GFA AD 614

GFA AIRWORTHINESS DIRECTIVE

Failure of Rudder Lower Mounting Bearing.

: Lower mounting of the rudder

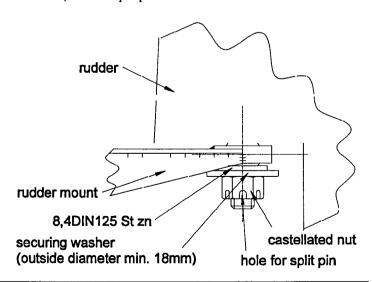
: On a DG-100 the universal bearing of the lower rudder mounting slipped out of the bearing support and the rudder fell out.

As the design is similar on all DG-types this kind of failure may occur on all DG's.

On later models this connection was secured by an extra securing washer.

Such a washer must be retrofitted to all DG-types with this TN.

- Check if the outer bearing ring is correctly in place in the rudder mounting, the ring should not be visible.
- If the bearing is out of place the rudder mounting must be removed and the bearing must be secured by peening with a chisel or the complete rudder mounting must be exchanged. In addition execute instruction 3 at the same time.

- 3. Check if a securing washer (min. outside diameter 18mm, 0.71 inch) is installed according to the sketch.
 - a) If yes: The execution of this TN can be entered in the aircraft logs by a licensed inspector without further work to be done.

- b) If no: Remove the castellated nut, install the washer 8.4 DIN9021 and reinstall the nut.
 - 1. Check if the washer is interfering with the rudder mount. If yes, use a washer 6,4DIN9021 St zn instead, enlarge the 6mm hole to 8mm to enable installation.

- 2. Check if the split pin can be installed. If yes, secure with a new split pin 2x20 DIN94 zn.

If this is not possible, mark the position for a new hole and remove the rudder. Drill a new hole (diameter 2mm, .08 inch) 90° to the existing hole. Reinstall the rudder, use new split pins.
